JAIPUR VIDYUT VITRAN NIGAM LIMITED

NO.JPD/SE (PLAN)/AEN (33KV works)/D. 506 JAIPUR, DATED: 4/4/18

Sub:- Regarding technical sanction of the estimates for bifurcation of 33 KV Rathibar feeder from 220 KV GSS Khushkheda.

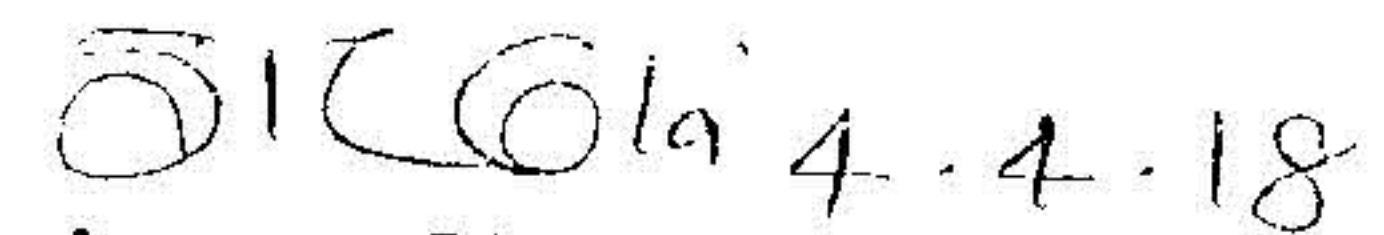
In context to above, it is to intimate that the proposal sent by you has been examined and it is to intimate that after proposal remaining 33 KV SICPA feeder and Rathibar feeder remain overloaded. Therefore, it is requested to please shift some load from overloaded feeders to other under loaded feeders or explore possibilities of creation of other new 33 KV feeders.

Therefore, it is requested to reply of observation at earliest through Zonal Chief Engineer (J/Z), so that further needful action may be taken by this office.
